Staff Report

To: Salt Lake City Planning Commission
From: Aaron Barlow, Principal Planner – 385-386-2764 – aaron.barlow@slcgov.com
Date: April 22, 2021
Re: Ville 9 Apartments - PLNPCM2020-00923 & PLNPCM2021-00098 – Design Review & Planned Development

Design Review & Planned Development

SHEET
SP-01

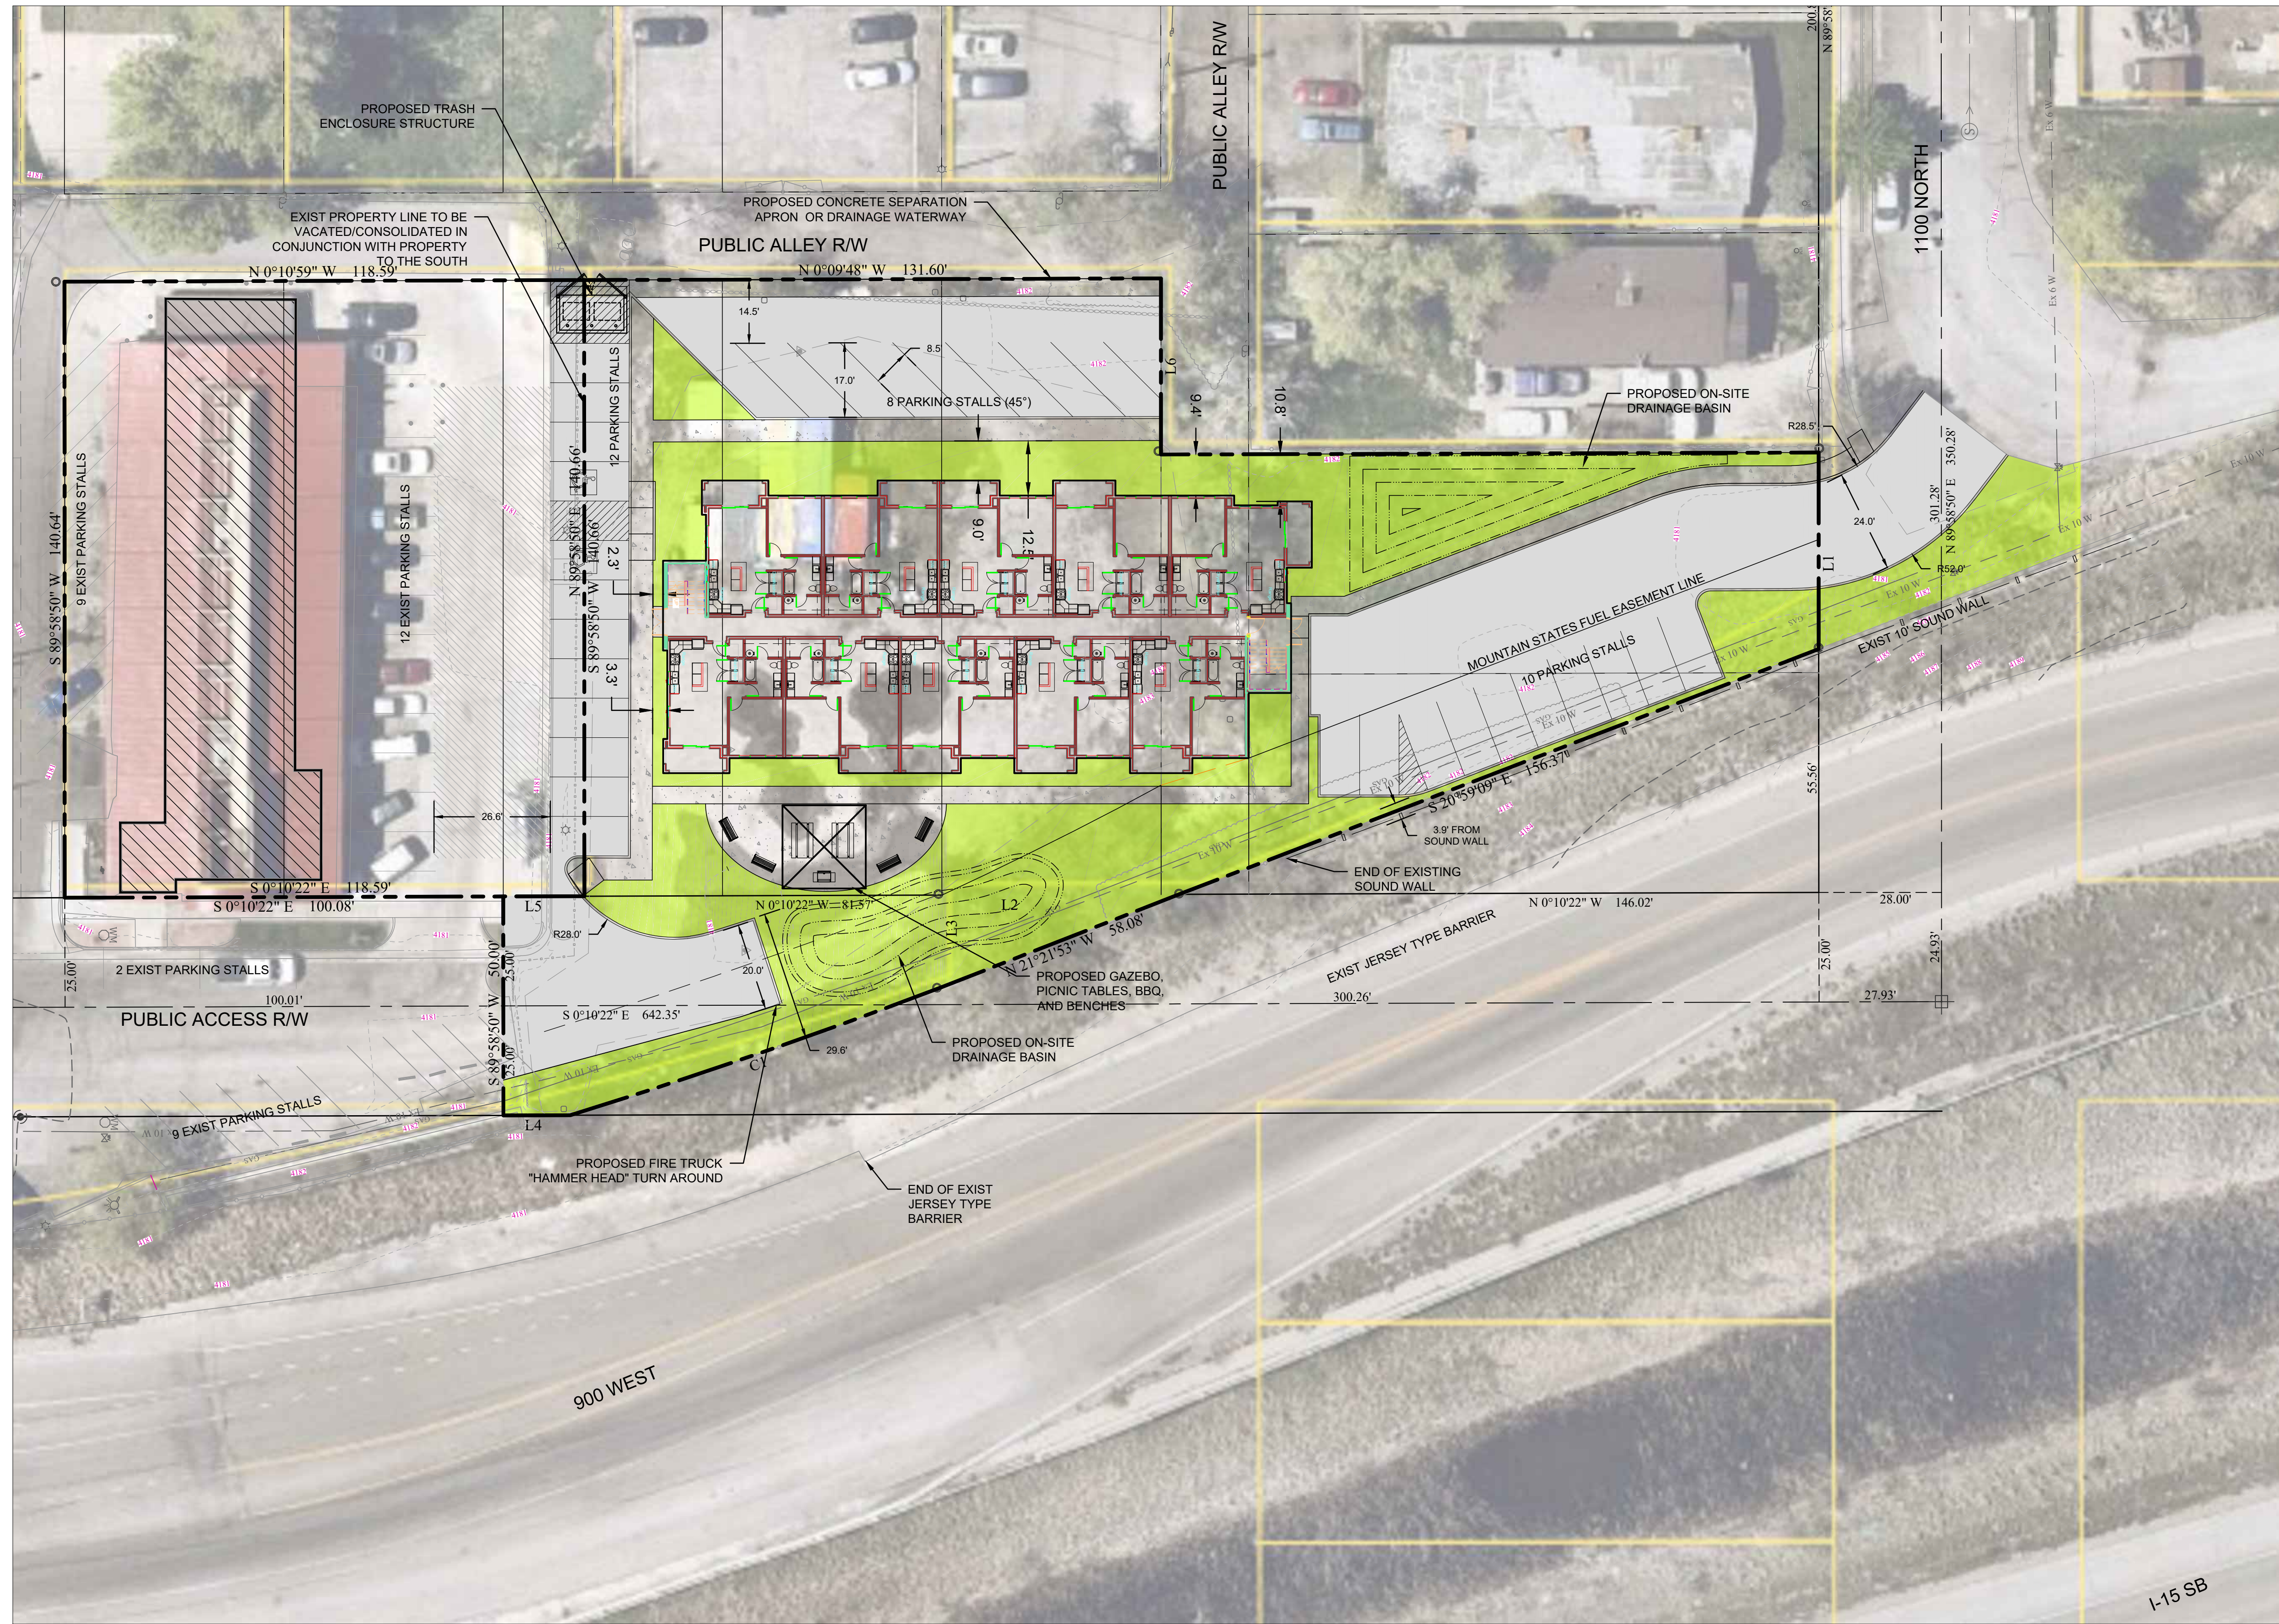
1. The building could be moved closer to 1100 North were it not for the parking lot in front of it. The applicant should study alternate site planning strategies that allow the building to be moved closer to the street.

2. The applicant should compensate for the additional distance between the building and 1100 North by providing the building with greater visual presence on 1100 North and designing the building's entrance so it is clearly identifiable from the street. The building as designed has no identifiable entrance. The façade facing the street has not been thought of by the designers as an entrance. The "front door" looks like an emergency exit. The building plans do not include a lobby or other entrance space.

1. The building could be moved closer to 1100 North were it not for the parking lot in front of it. The applicant should study alternate site planning strategies that allow the building to be moved closer to the street.

2. The applicant should compensate for the additional distance between the building and 1100 North by providing the building with greater visual presence on 1100 North and designing the building's entrance so it is clearly identifiable from the street. The building as designed has no identifiable entrance. The façade facing the street has not been thought of by the designers as an entrance. The "front door" looks like an emergency exit. The building plans do not include a lobby or other entrance space.
3. The project's street presence should also be enhanced by the applicant by repaving the block of 1100 North abutting the property, providing a sidewalk and installing enhanced street lighting to improve security.

SHEET
EX-05

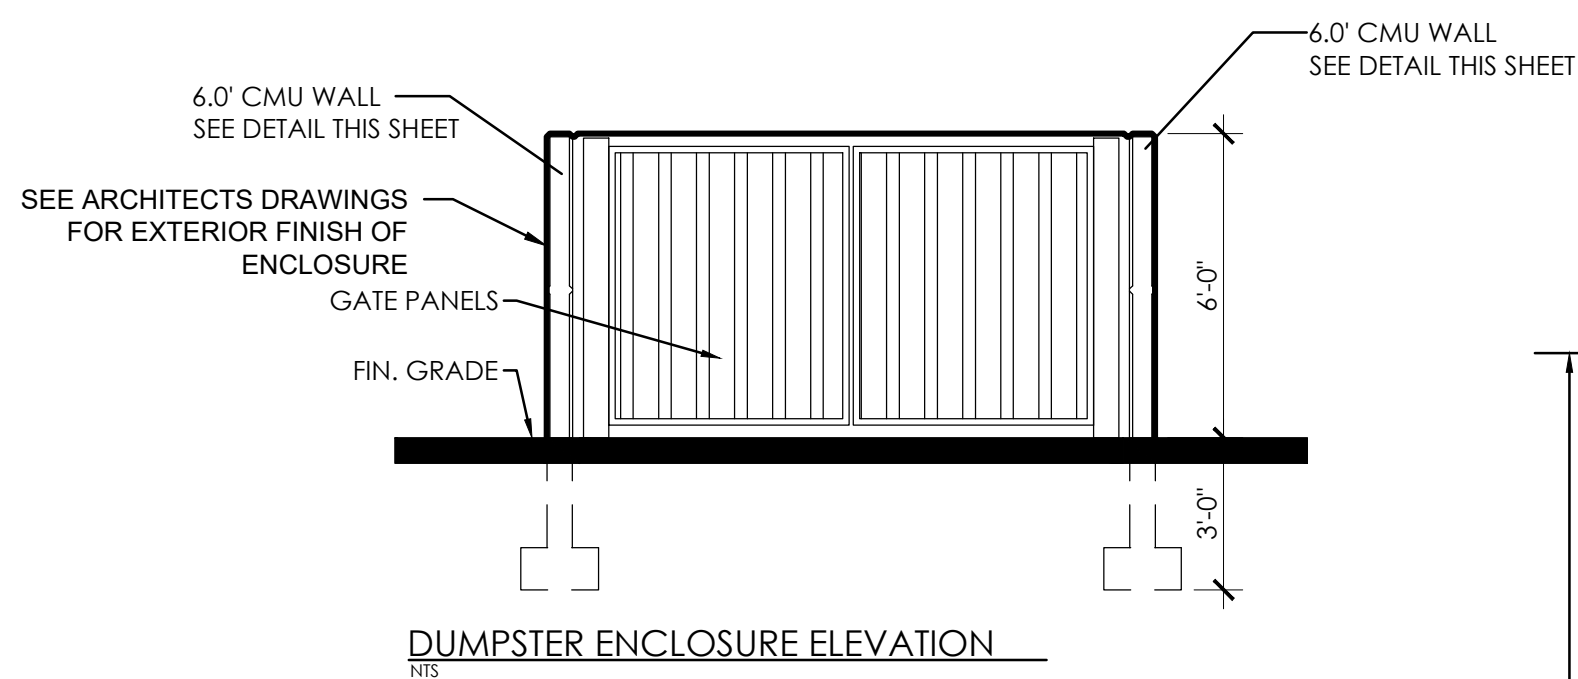
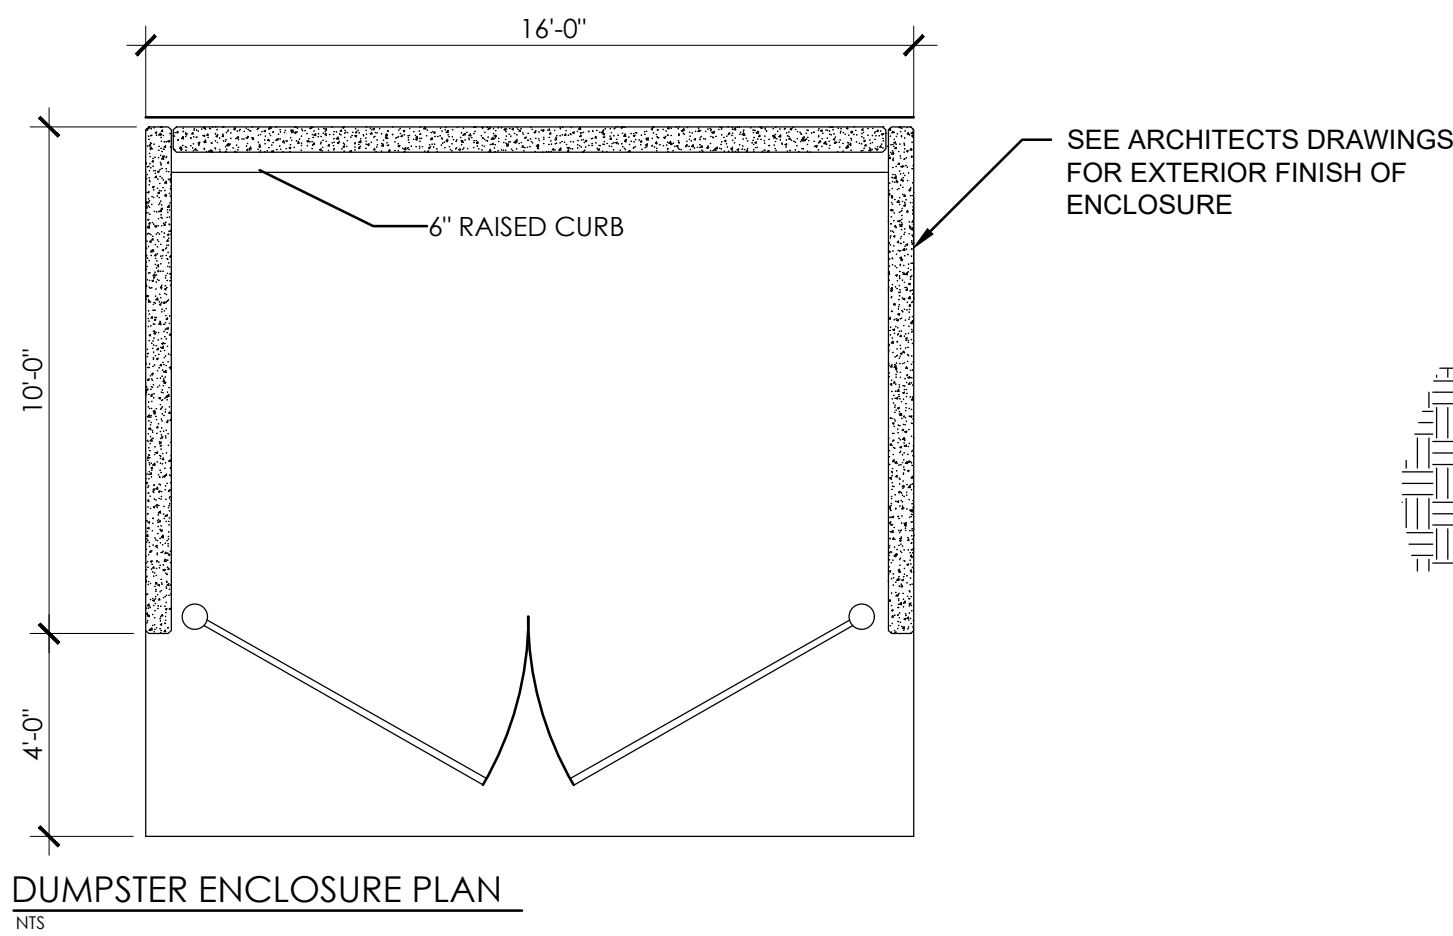
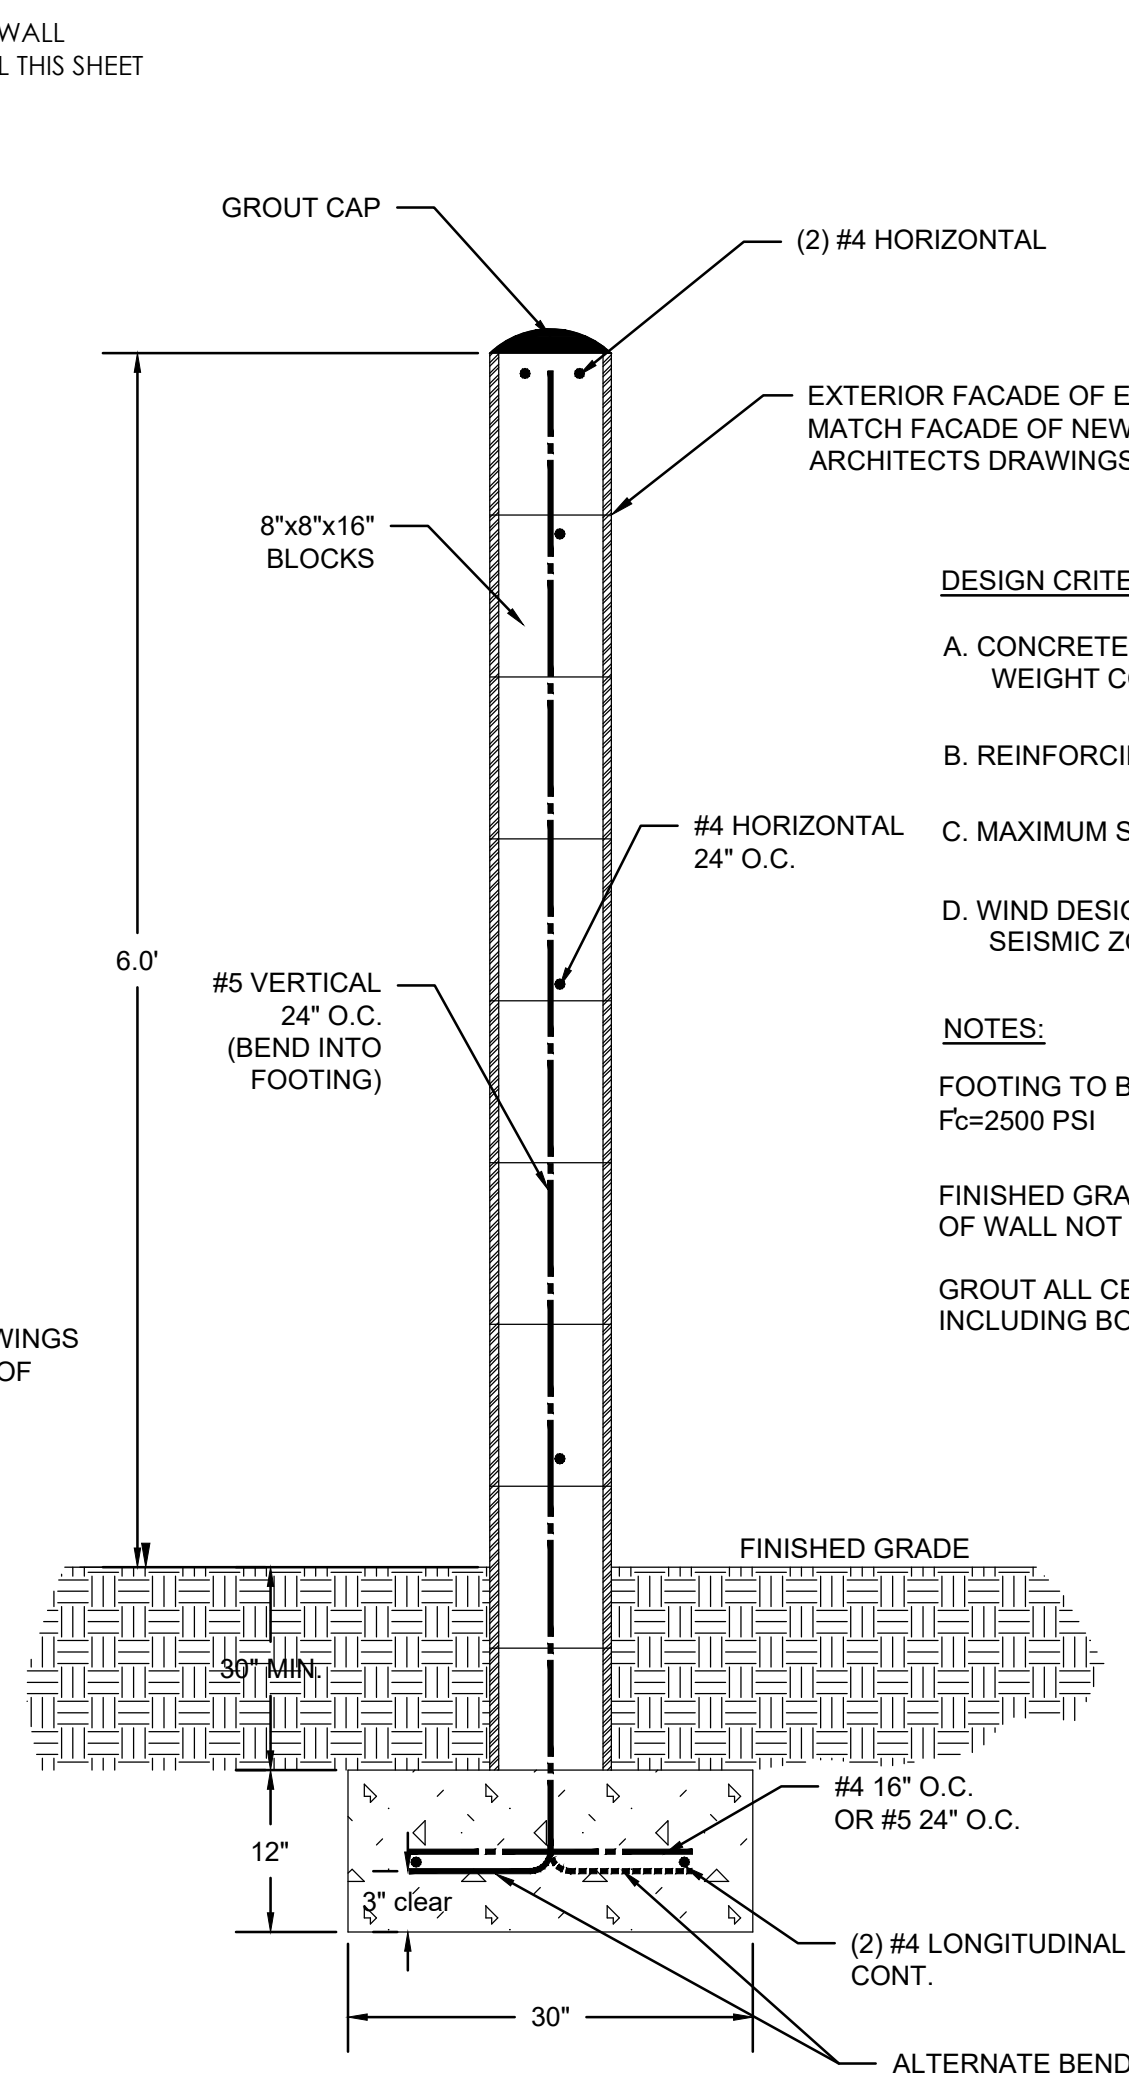
6. Whether dumpsters, loading docks and/or service areas are appropriately screened; and		The proposed dumpster will be screened on all sides.
7. Whether parking areas are appropriately buffered from adjacent uses.		Proposed parking is either within existing lots, adjacent to alleys, or set back and pointed away from adjacent uses.
<p>D. Landscaping: The proposed planned development preserves, maintains or provides native landscaping where appropriate. In determining the landscaping for the proposed planned development, the Planning Commission should consider:</p>	Complies	The applicant has provided a landscaping plan that generally meets relevant standards found in section 21A.48 and the standards listed as part of this objective.
